## INTRODUCTION

Since the introduction of the THM 440-T4 Transaxle in April, 1984, there have been many major engineering design changes. These changes have affected nearly every part used in the THM 440-T4. This Update Handbook will explain each change, the parts affected by the change, and any parts interchangeability problems created by the change.

### THM 440-T4 PUMP INFORMATION

Figure 5

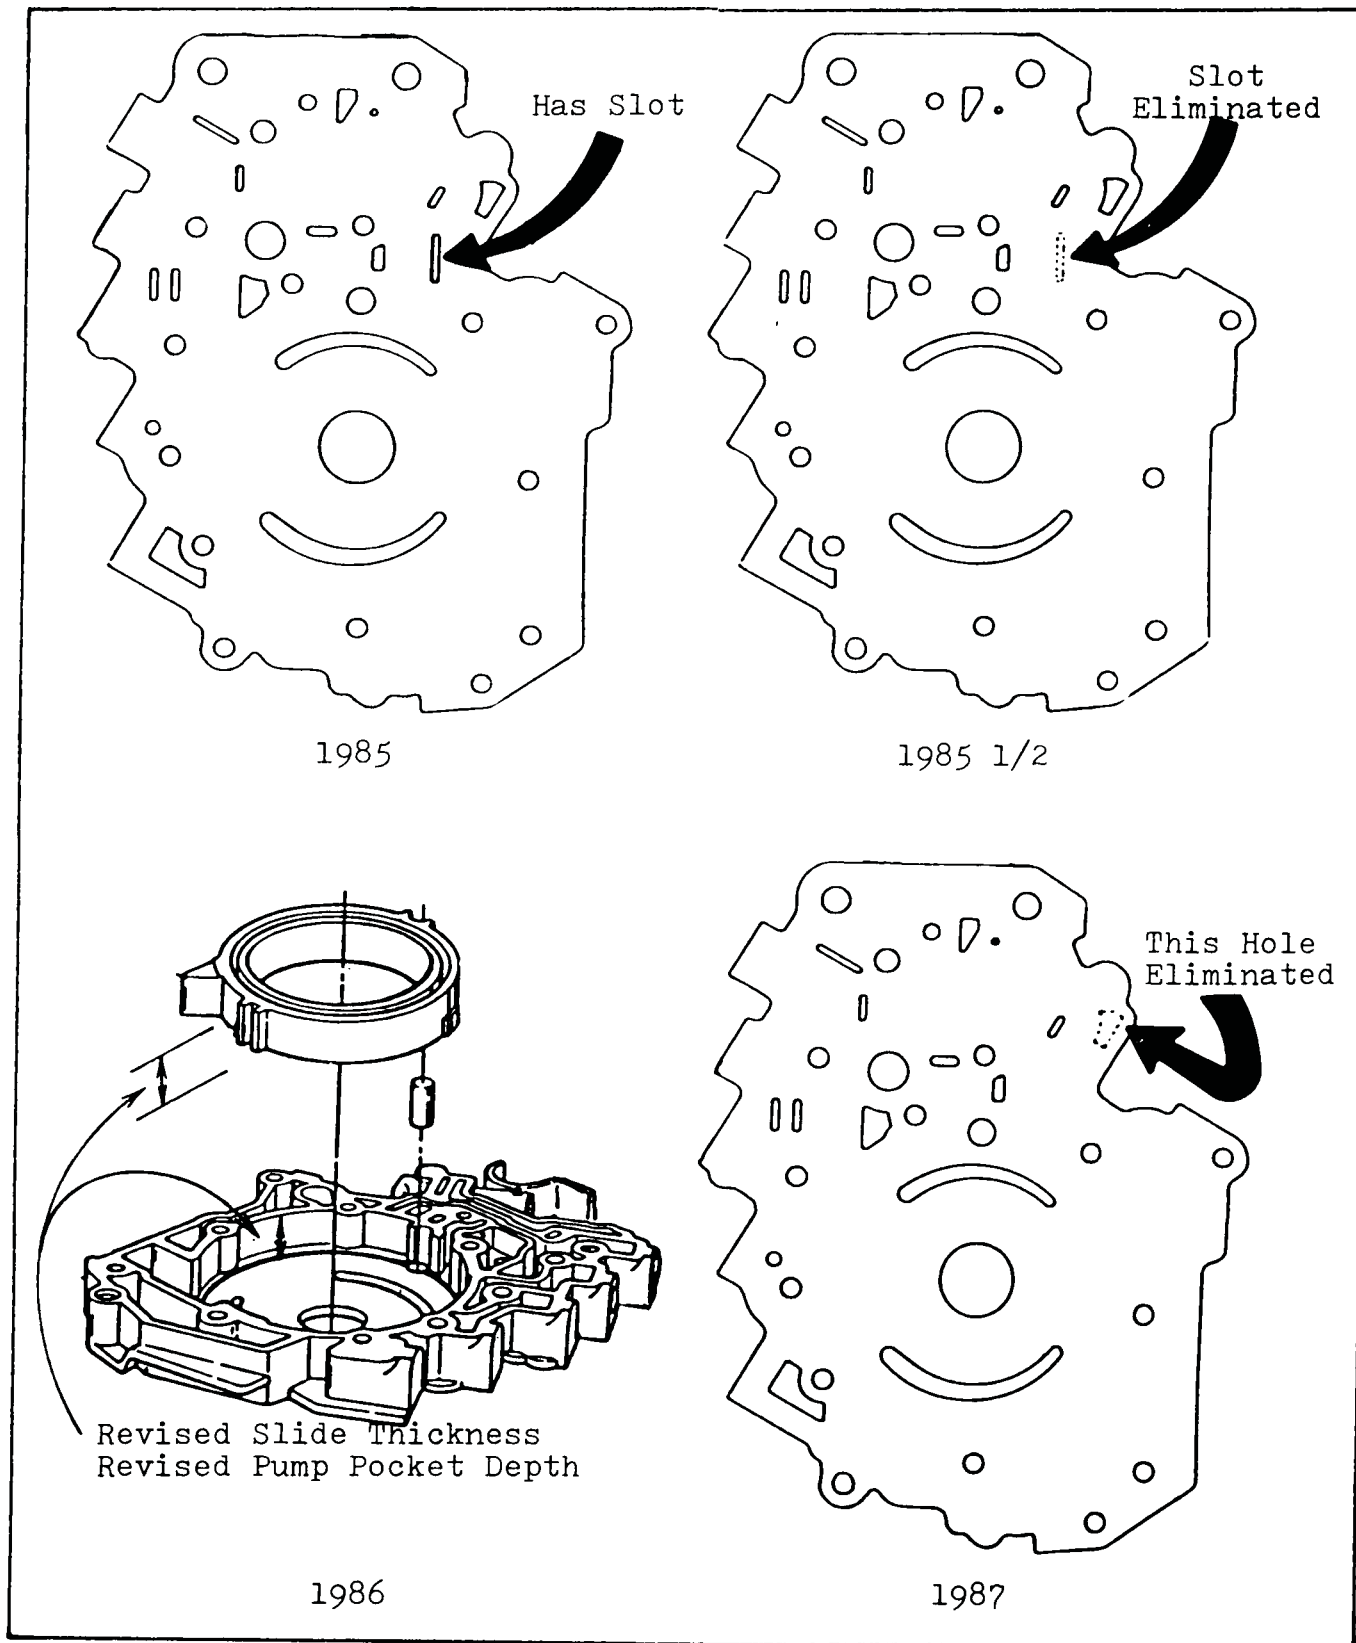
1985	Identification:	Has slot in pump body (See Figure 5).
	Interchangeability:	The 1985 pump body will not work on 1985 1/2 up valve body unless spacer plate is used to eliminate slot. If used without the spacer plate result will be tie-up when transaxle shifts to 4th gear.
1985 1/2	Identification:	Slot in pump body was eliminated (See Figure 5).
	Reason:	Addition of 3-2 TV bias valve in valve body and complete revision of hydraulic circuit for improved 3-2 downshift.
	Interchangeability:	Will interchange on 85 1/2 and 1986 models only.
1986	Identification:	No way to identify from 1985 1/2. Pump pocket depth was made shallower by .001" which created 5 new slide sizes unique to the 1986 pump. See chart on page 6.
	Reason:	Improved pump capacity.
	Interchangeability:	Will interchange with 85 1/2 only, as long as proper slide selection is made to correspond with depth of pump pocket.
1987	Identification:	Hole eliminated in pump body (See Fig. 5).

Reason:	Improved 3-2 downshift. Modulator oil was fed thru the hole in pump body to stroke the 3-2 coastdown valve. Improved 3-2 downshift could be obtained by using servo release oil to stroke the valve, so hole was eliminated and the 3-2 maneuver pipe was added to carry servo release oil to the 3-2 coastdown valve in pump body (See Figure 6). This also made a change in the pump cover necessary with an additional hole and seal to accept the 3-2 maneuver pipe.
	Interchangeability:	Will retro fit back to 85 1/2, and is recommended. The 3-2 maneuver pipe must be used with it. Not interchangeable unless 3-2 maneuver pipe is used.

Figure 7

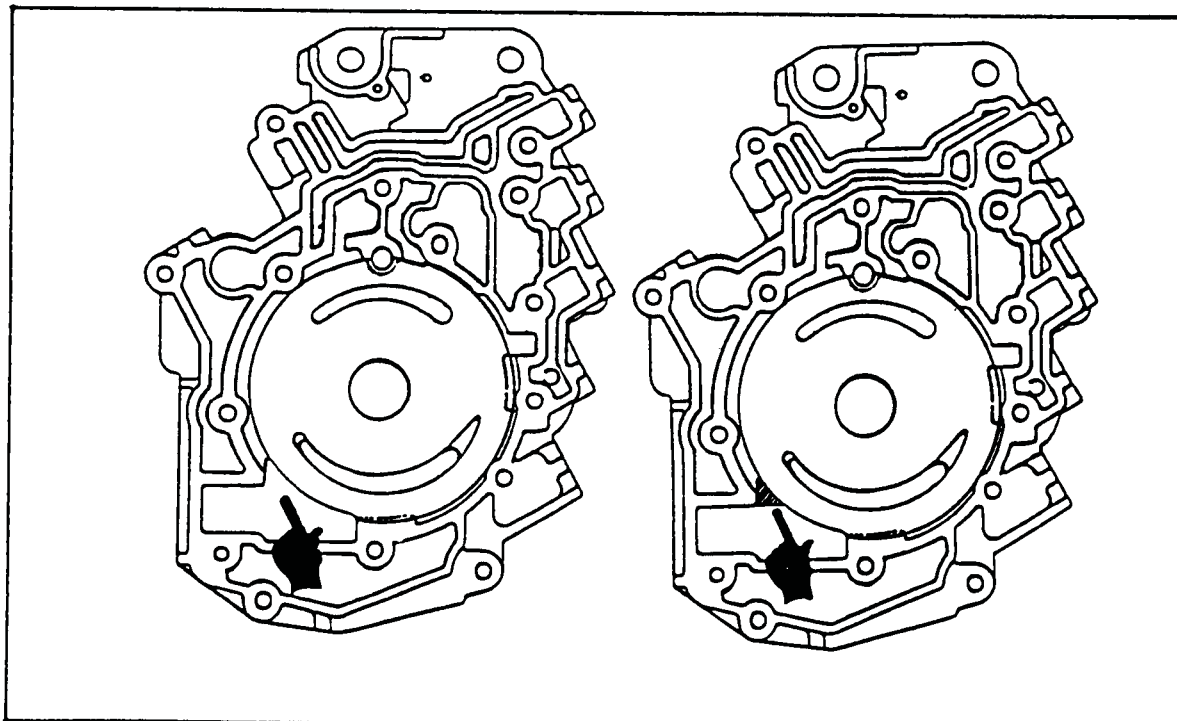
If flash is present you will have to replace the oil pump assembly, or use a Dremel Tool with a carbide bit and remove flash from 87 model to match contour of 86 model (See Figure 7).

Figure 16

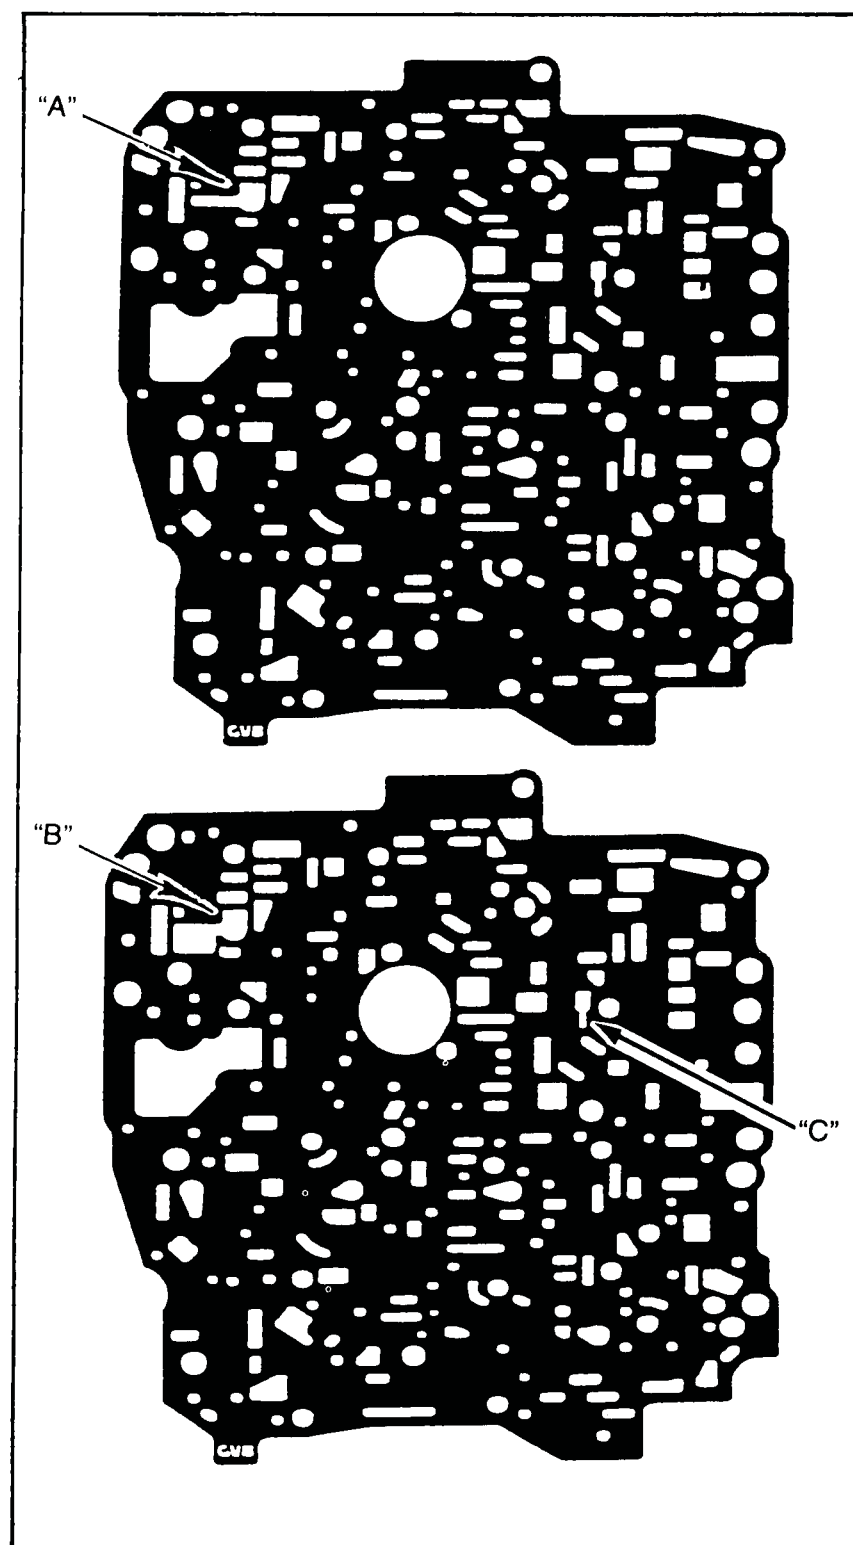
Note the difference in the "Pipe Stem" between "A" and "B", Figure 16. This change occurred about Oct. 1985.

In June 1987 the "Finger" shown at "C", Figure 16 was made Approx. .020 wider.

Figure 18 (1985 1/2 - UP)

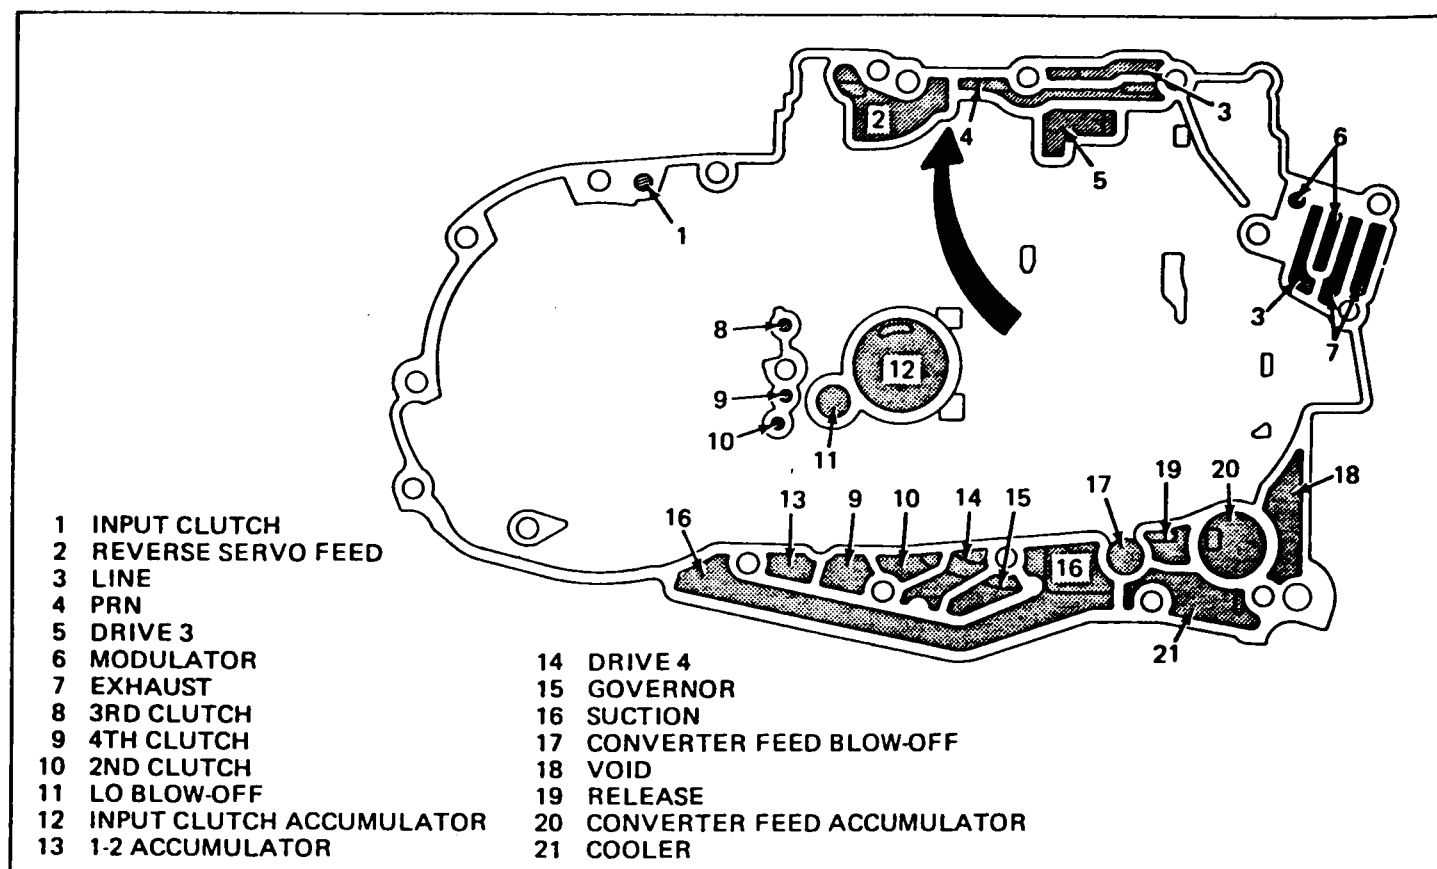
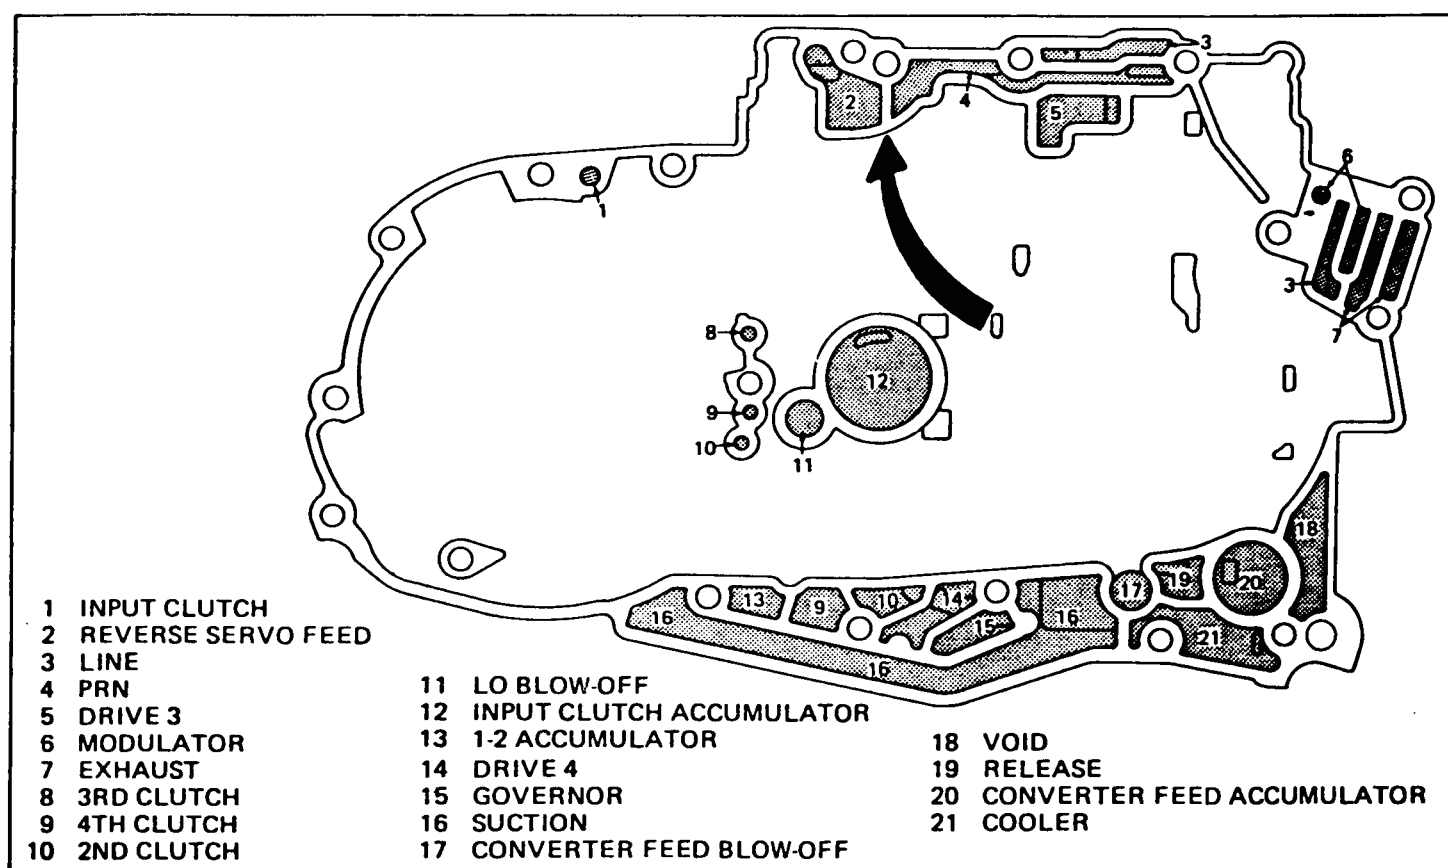
Identification: The easiest way to identify the channel plates apart is the location of the dam in the upper channel plate worm track area. (See Figure 17 and Figure 18). The dam was moved to an area directly under the upper dowel pin bore.

Reason: Complete change in hydraulic system for improved 3-2 downshift.

Figure 20

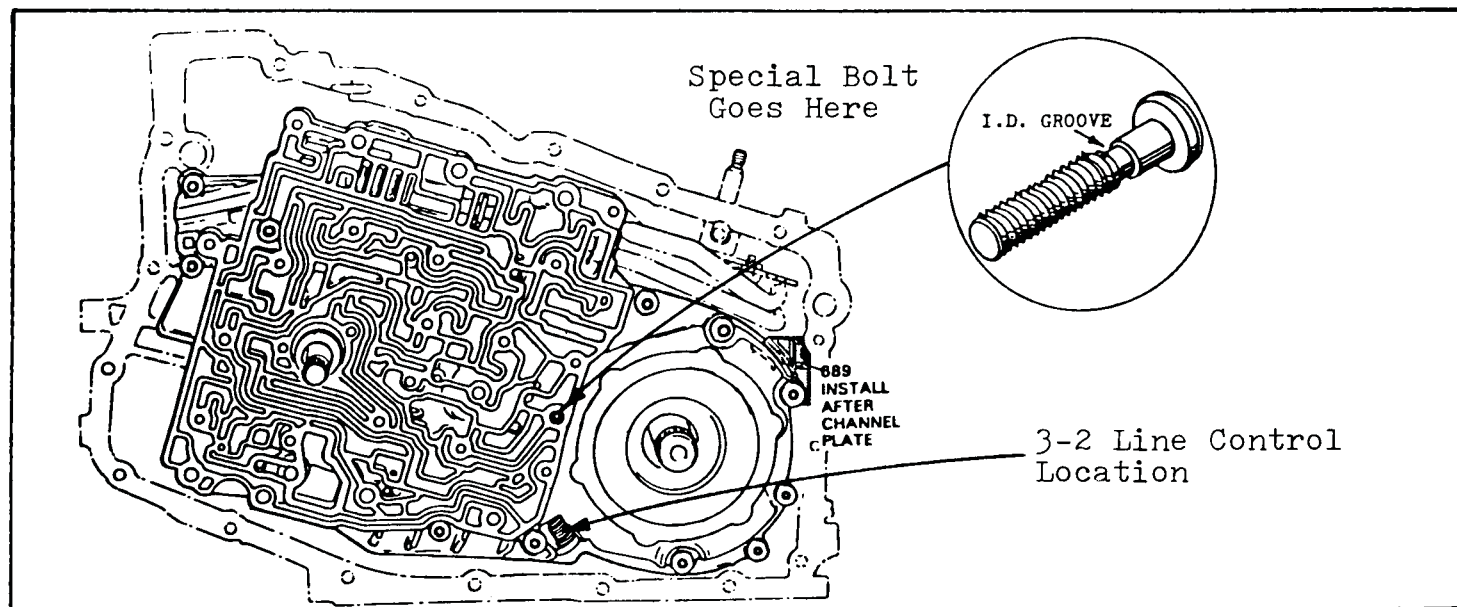
- 2) The 3-2 line control valve located in the channel plate (See Figure 20 For Location), was changed from a single valve, to a two piece valve (See Figure 21). The 2 piece is connected together with a small clip that has a bad habit of breaking, and will create no 3-2 downshift.

Figure 21

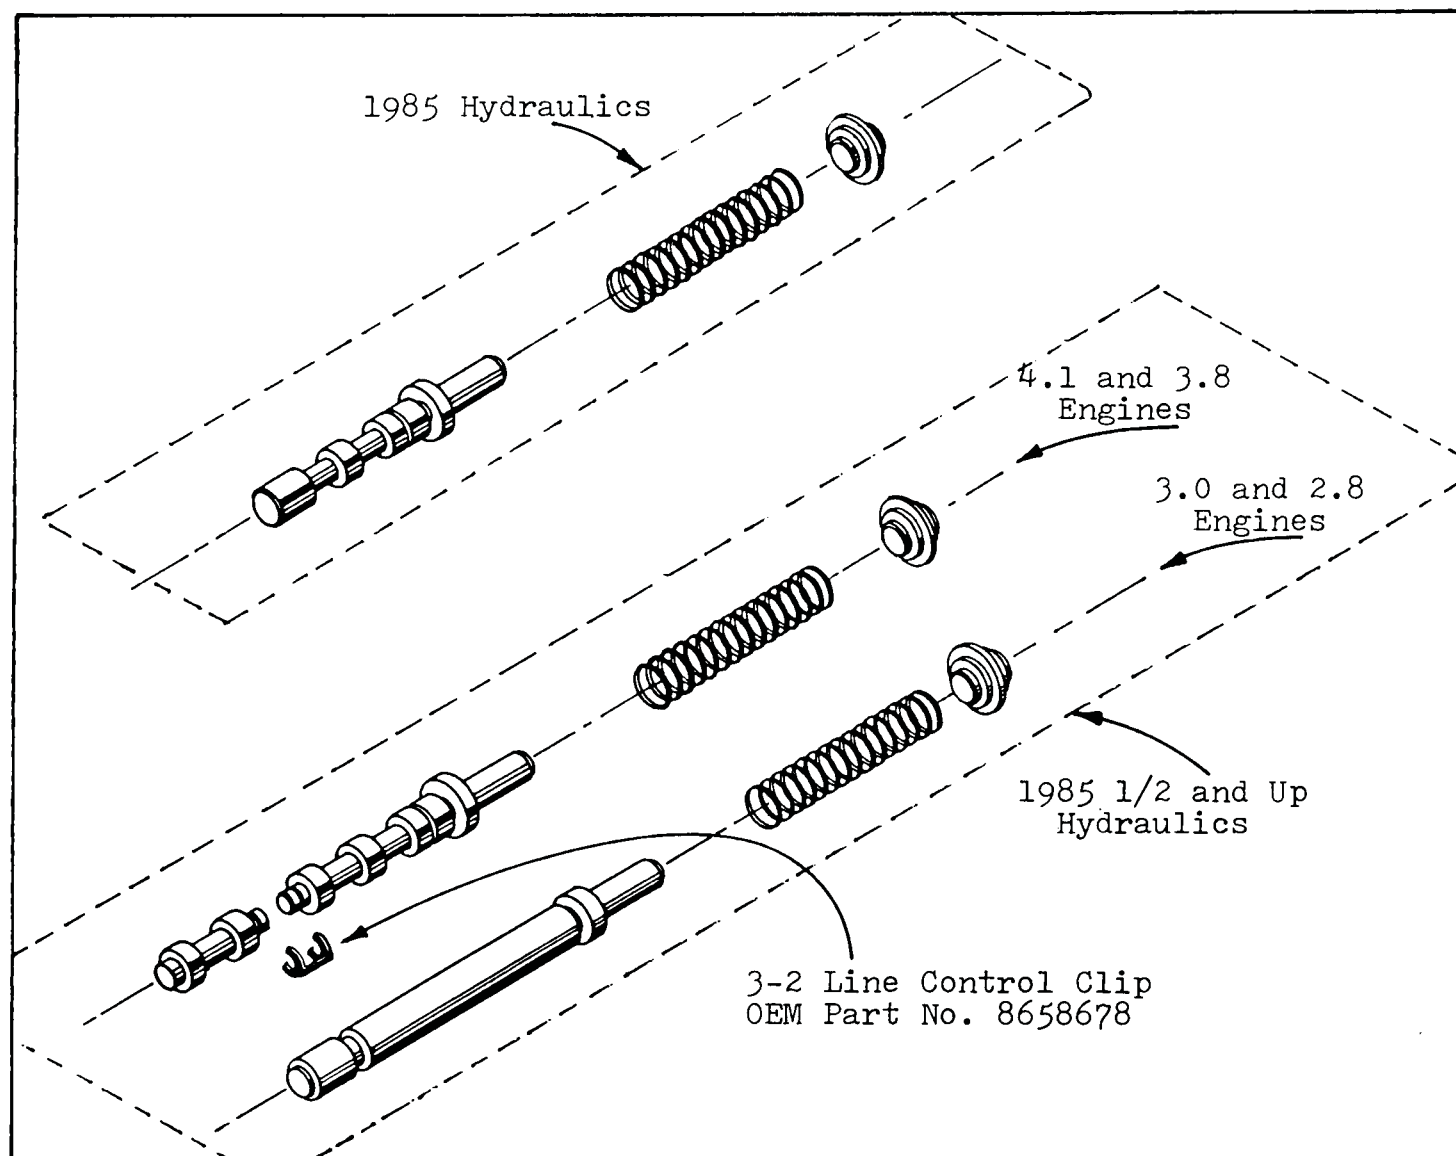
Also notice (See Figure 21) that there are 2 line ups for the 85 1/2 and up models. The 2 piece 3-2 line control valve is used on 4.1 Cadillac, and 3.8 Buick engines. The "Plug" that is also shown (Figure 21), is used on 3.0 Buick, and 2.8 Chevrolet engines.

Figure 22

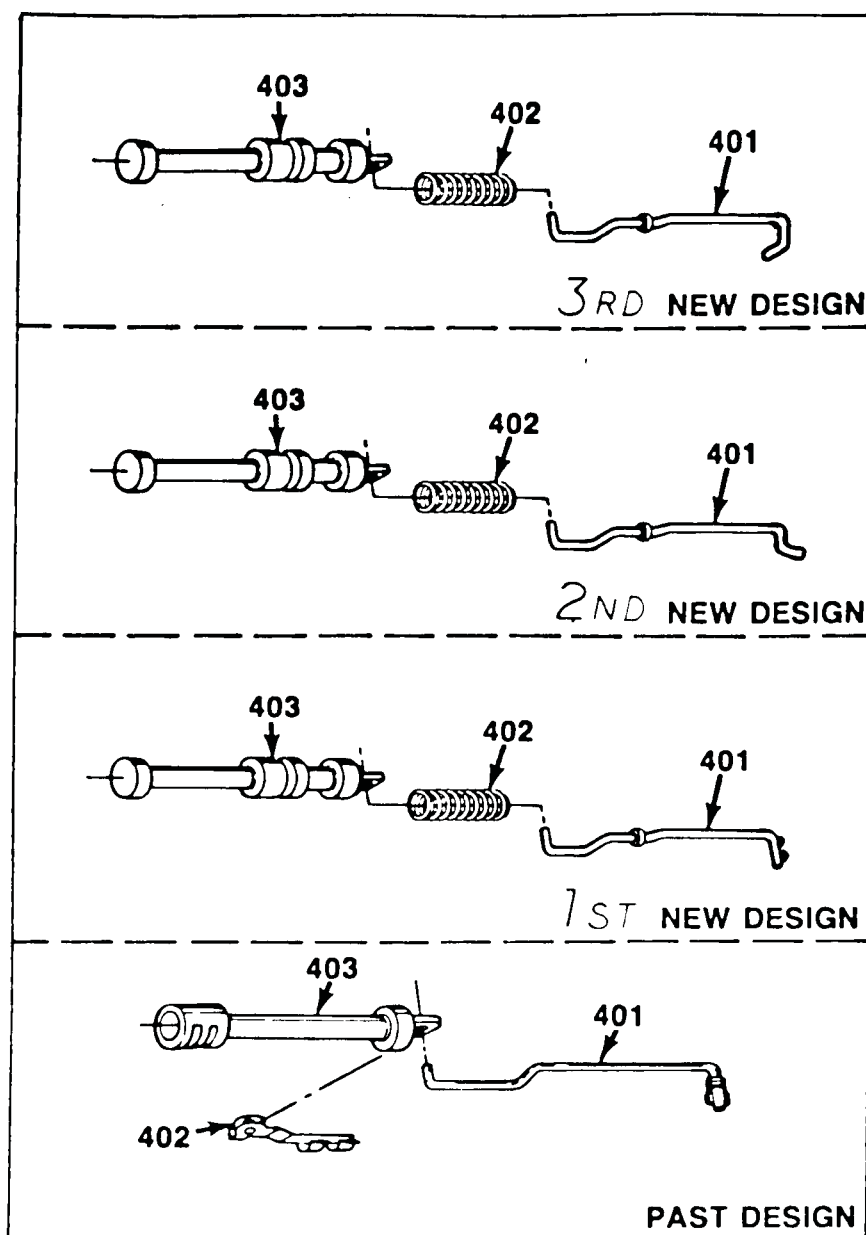
- 3) There has also been some re-design of the manual valve, retainer clip, and manual link to assist in the assembly process (See Figure 22).
